JUDY TUTTLE &
ROBERT D. CARBARY

PART OF THE SW. 1/4
OF SEC. 13, T-19, R-19,
PERRY TWP., RICHLAND
CO., OHIO.

**SURVEYOR'S DESCRIPTION FOR
JUDY TUTTLE & ROBERT D. CARBARY**

Lot Split Application By:

PART OF THE SW. 1/4
OF SEC. 13, T-19, R-19,
PERRY TWP., RICHLAND
CO., OHIO.

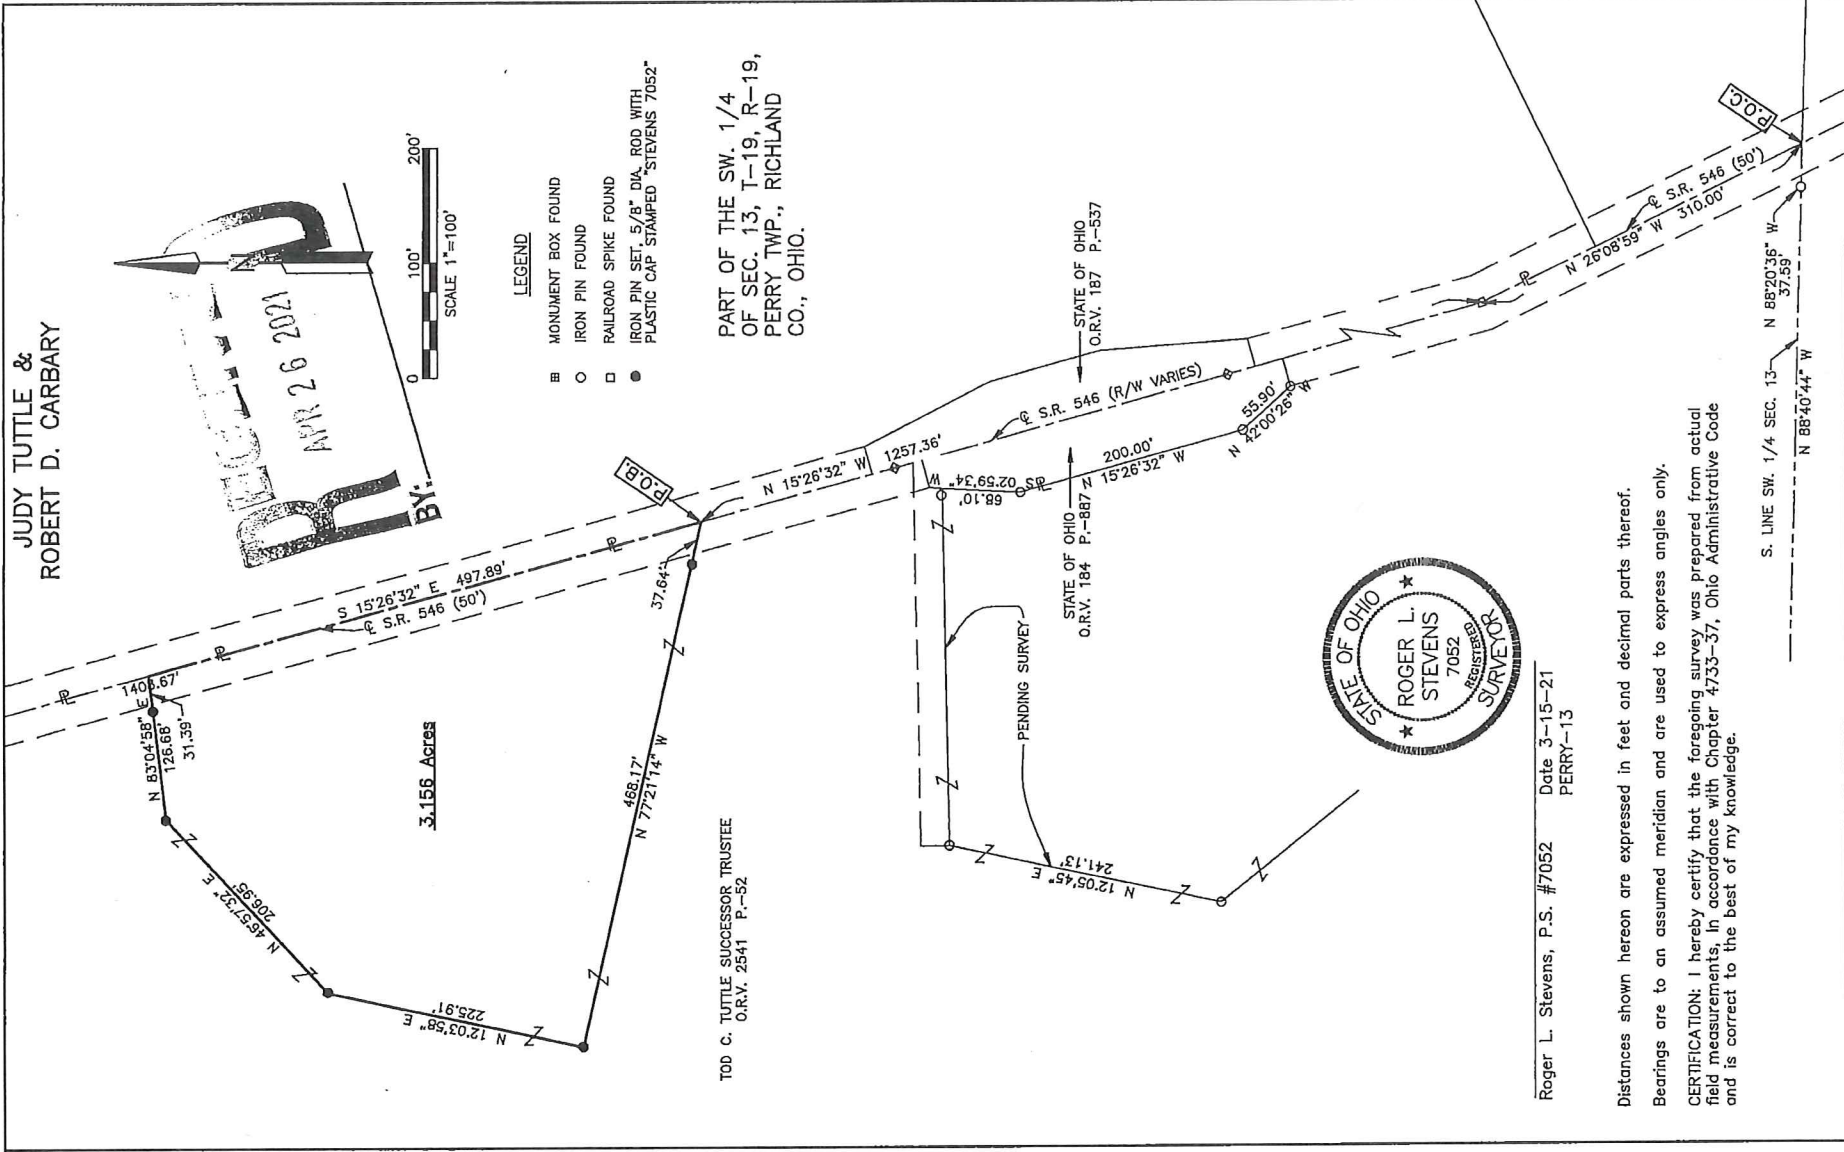
Comments: AREAS DESIGNATED FOR INSTALLATION OF SEPTIC SYSTEM AND THE REPLACEMENT AREA SHALL BE UNDISTURBED AND PROTECTED FROM DAMAGE OR DISTURBANCE
